**Merged Document Report****Application No.: PL9333**

Description :	
Address :	
Record Type :	PLAT

PLAT OF
ROYAL OAK SOUTH UNIT 2

ROYAL OAK SOUTH UNIT 2 CORPUS CHRISTI, TX	WASTEWATER PLAN		T&E ENGINEERING CIVIL • WINDSTORM • CONSULTING F-19879 6837 SIR MOSES CORPUS CHRISTI, TX 78414	
--	------------------------	---	--	--

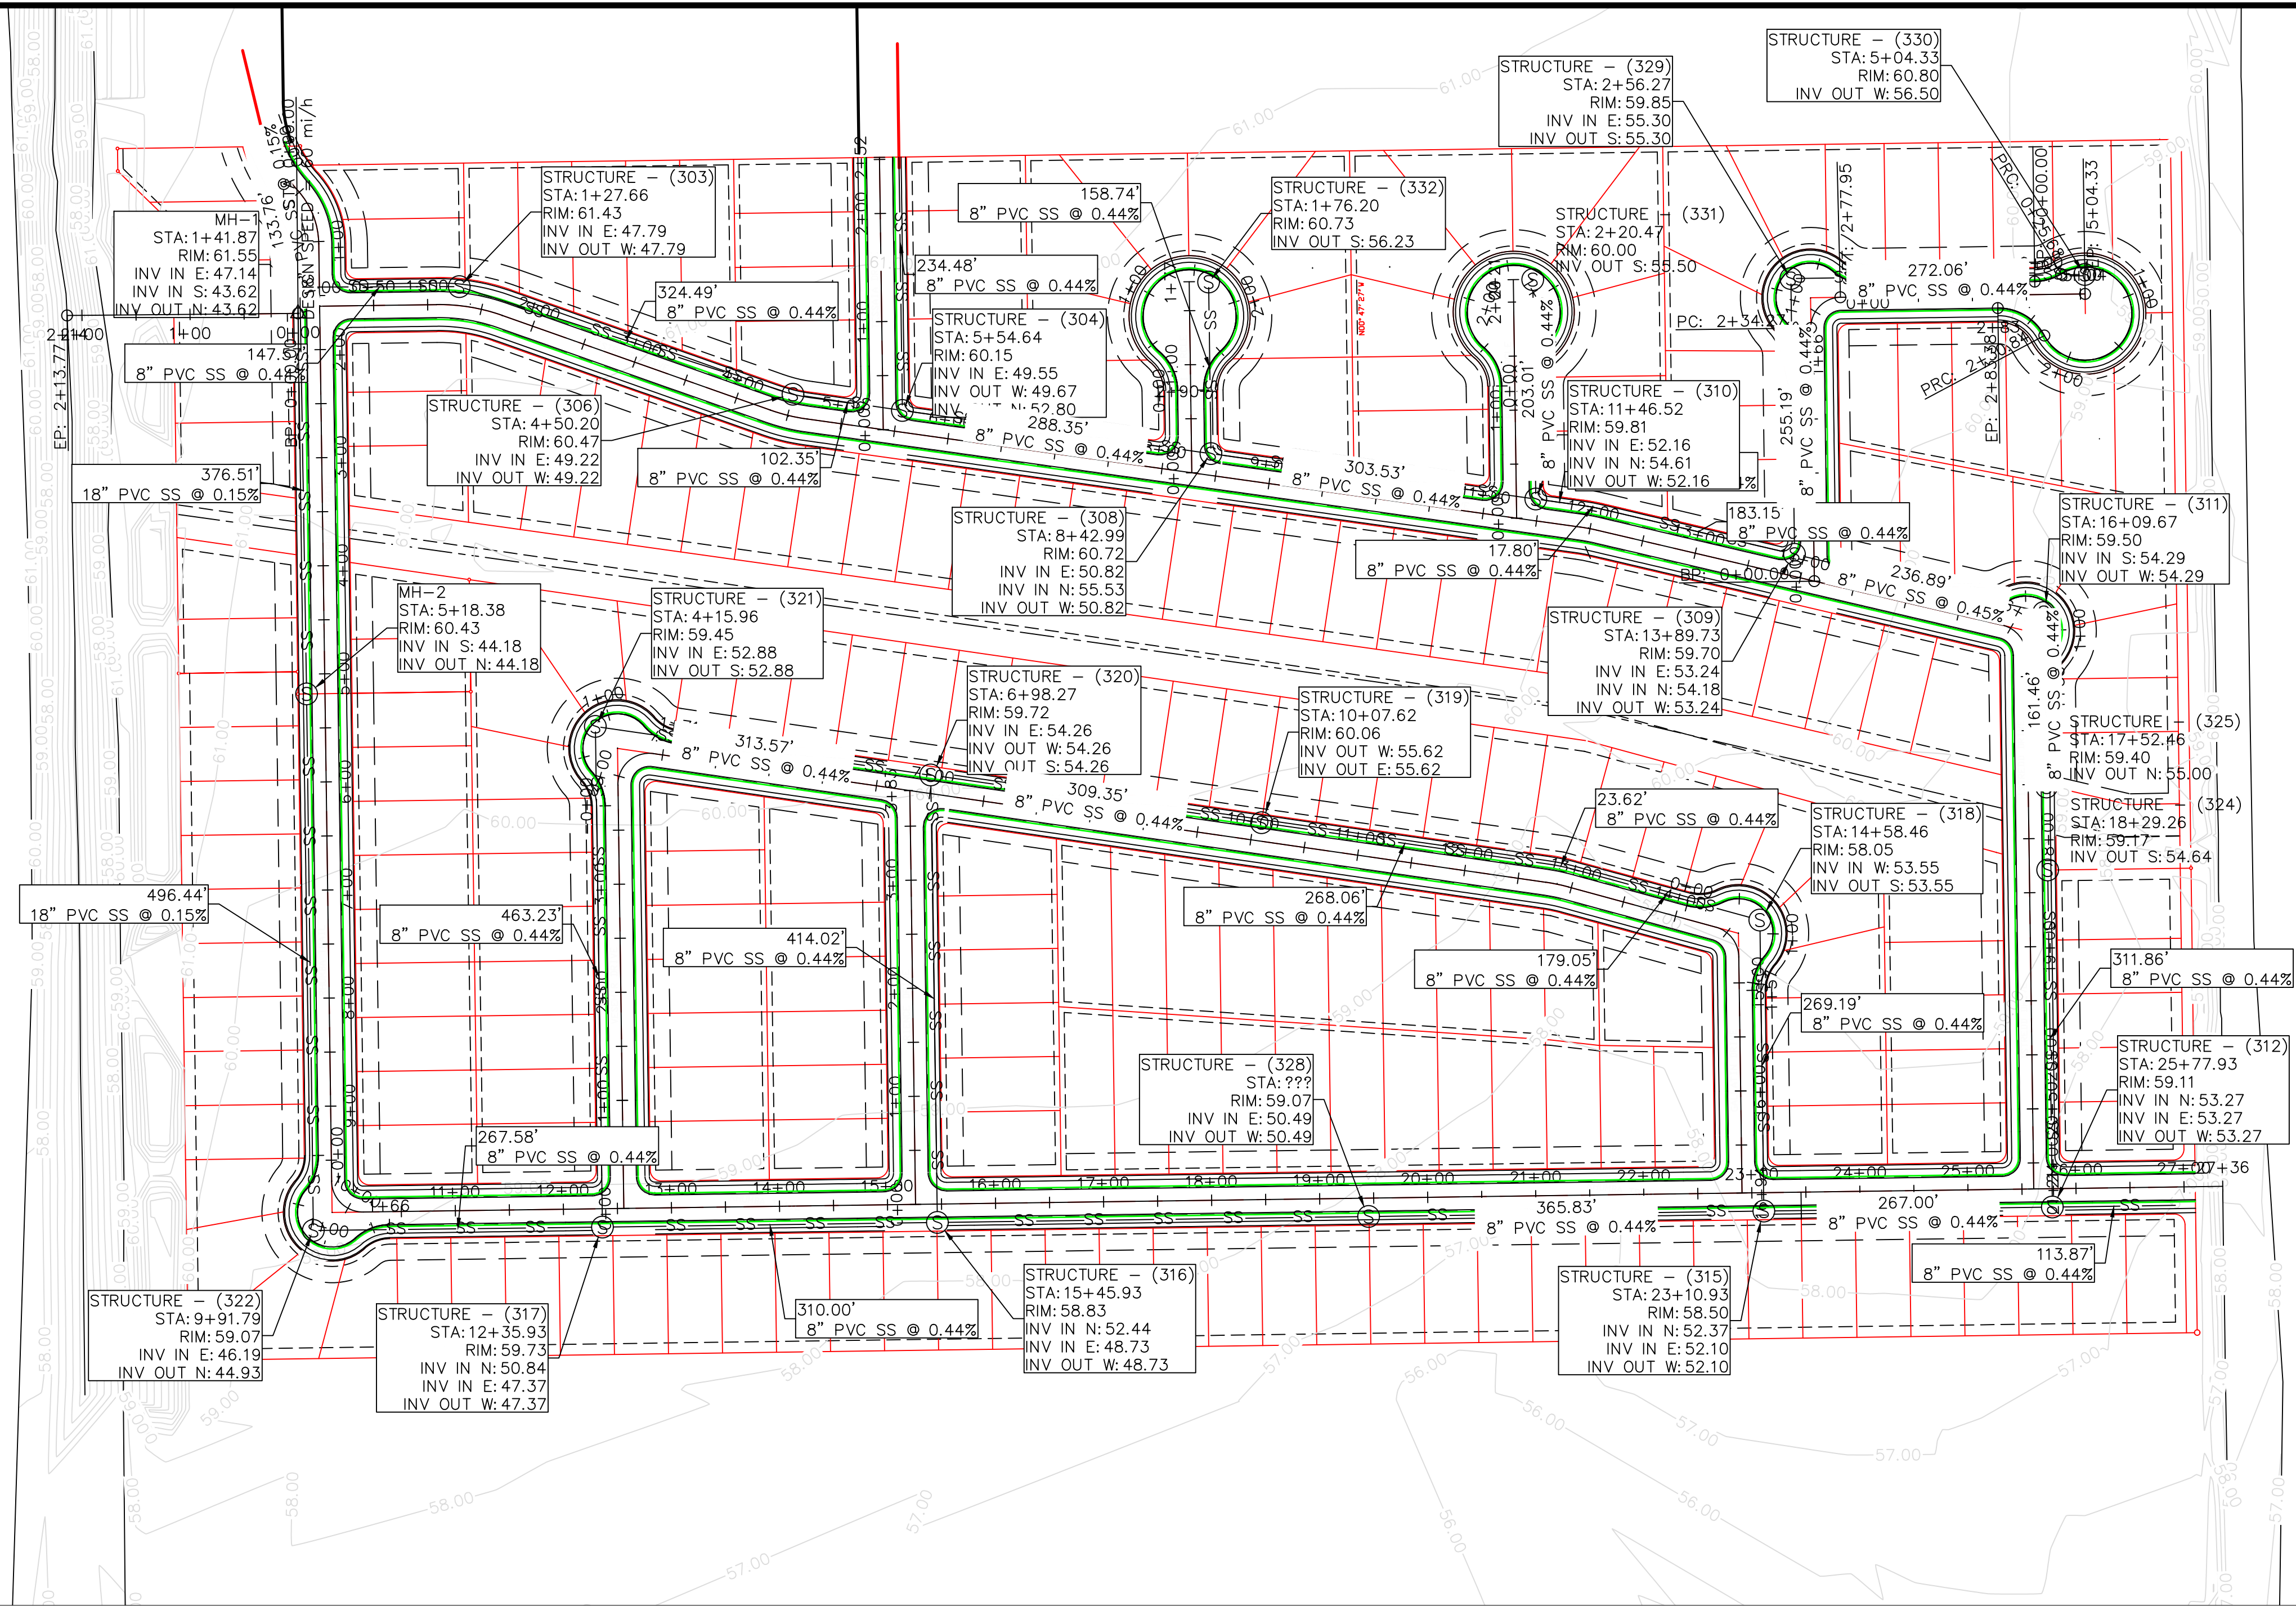
29	ROS BASE-WW (2)	Note	Bria Whitmire : DS	Closed	As this includes all of Units 2 and 3, highlight or add notes concerning specifically Unit 2's temporary stub outs and/or cul-d-sacs for Unit 3.	
4	P001	Note	Mark Zans : LD	Closed	Gas Company comments: gas company request 5' U/E at the following locations: 1. Five-foot U/E along north property line of Lot 8 Block 2 2. Five-foot U/E along east side of Lot 81 Block 6. 3. Five-foot U/E along east property line of Lot 76 Block 6 4. five-foot U/E along the east property line of Lot 70 Block 6 5.Five - foot U/E along the east property line of Lot 64 Block 6 6. Five-foot U/E along the south property line of 47 Block 5	
5	P001	Note	Mark Zans : LD	Closed	Change Michael Dive title to Interim Asst. City Manager	
6	P001	Note	Mark Zans : LD	Closed	Hatch street dedication area and provide square footage of area.	
7	P001	Note	Mark Zans : LD	Closed	Add note that Lot 14 Block 2, Lot 4 Block 6, and Lot 72 Block 5 are unbuildable lots due to easements.

ROYAL OAK SOUTH UNIT 2 CORPUS CHRISTI, TX	STORM WATER PLAN		T&E ENGINEERING CIVIL • WINDSTORM • CONSULTING F19879 6837 SIR MOSES CORPUS CHRISTI, TX 78414	
--	-------------------------	---	---	--

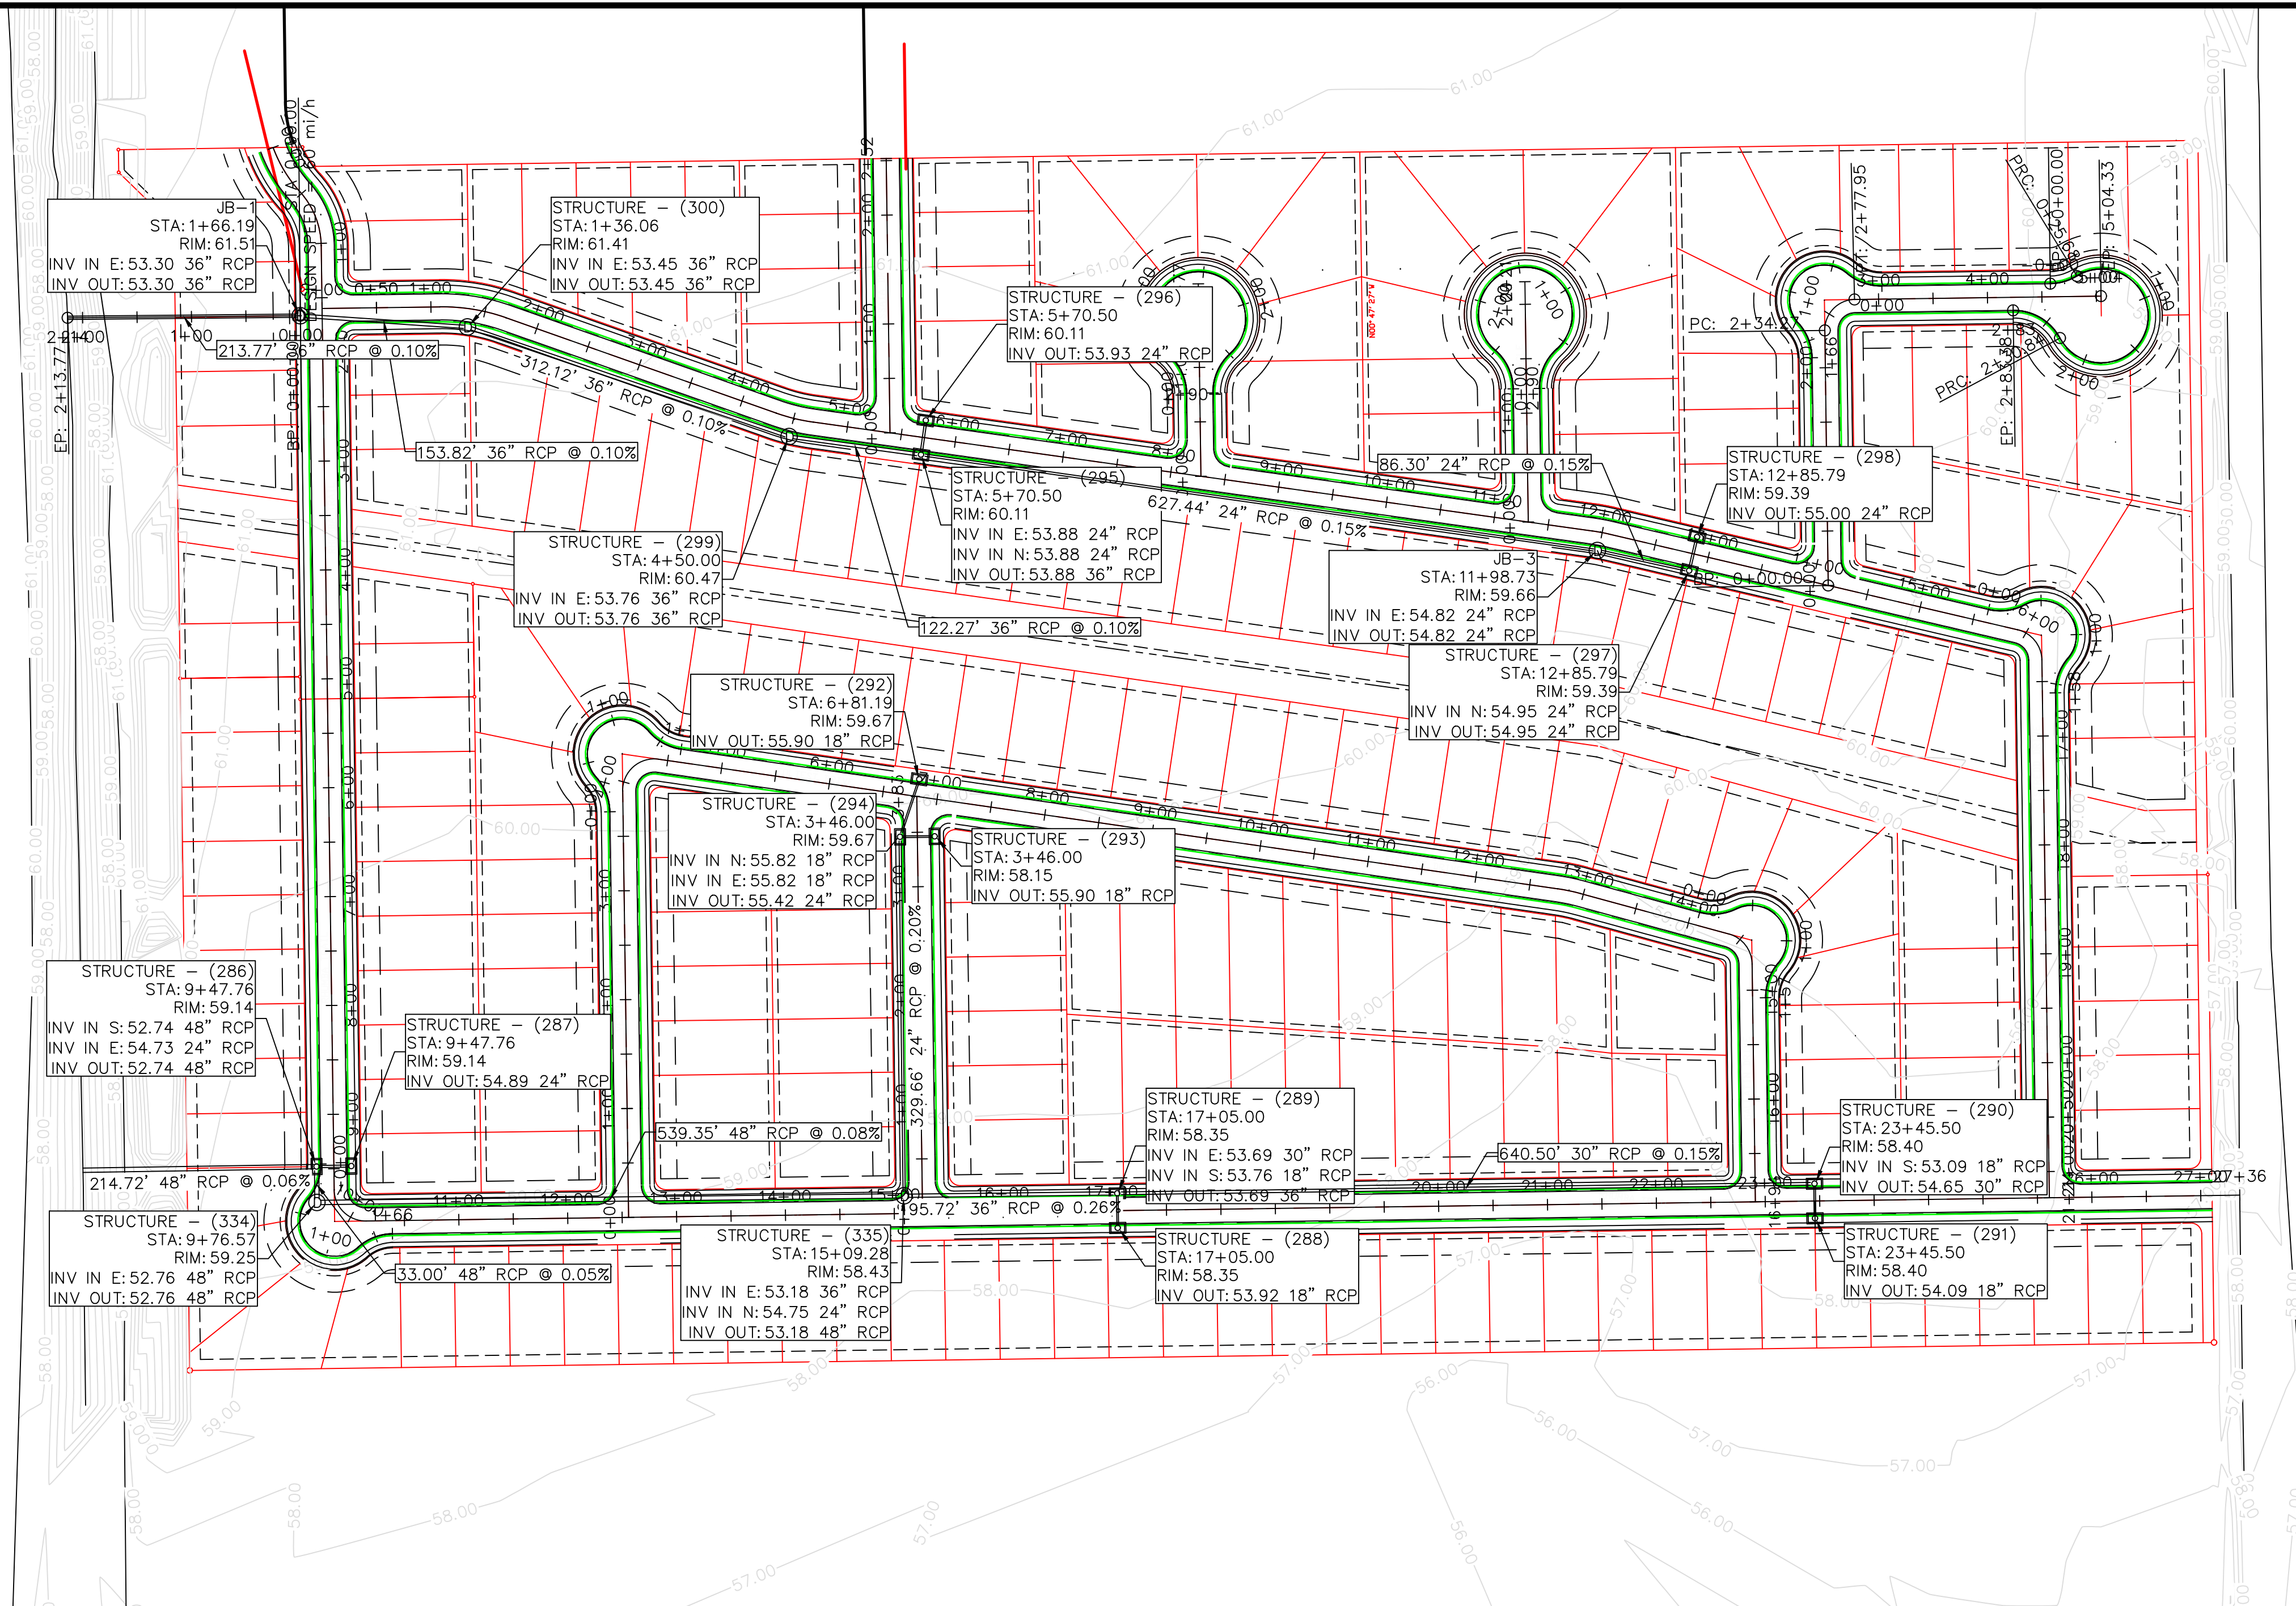
21	P001	Note	Mark Zans : LD	Closed	Stormwater comments #2: Storm Water Note #4 states: "MITIGATION OF STORAGE WILL OCCUR IN THE STREETS PRIOR TO BEING RELEASED TO THE DITCH." Comment: (Please confirm in PI phase) □The IDM dictates strict allowable flow depths during design storms (e.g., the 5-year storm must remain within the curbs, and the 100-year storm must not exceed the right-of-way lines or exceed a depth that threatens finished floor elevations). □Relying on street storage for mitigation requires

Comment ID	Page Reference	Annotation Type	Author : Department	Status	Review Comments	Applicant Response Comments
					a comprehensive 100-year ponding and street capacity analysis to verify that maximum depth limits are not breached, and emergency vehicle access is maintained Storm Water Note #5 states that the underground conduits will be phased and will "initially discharge into a temporary ditch that outfalls into the existing drainage channel." (1)□Comment: (Please confirm in PI phase) •□Provide dedicated construction details, cross-sections, and temporary drainage easements (TDE) for this interim ditch. •□A phasing analysis must prove that intermediate phases will not overwhelm downstream segments before the final underground network is fully built out and tied into the ultimate channel. •□Temporary erosion and sediment controls (SWPPP) must explicitly account for the stabilization of this temporary channel.
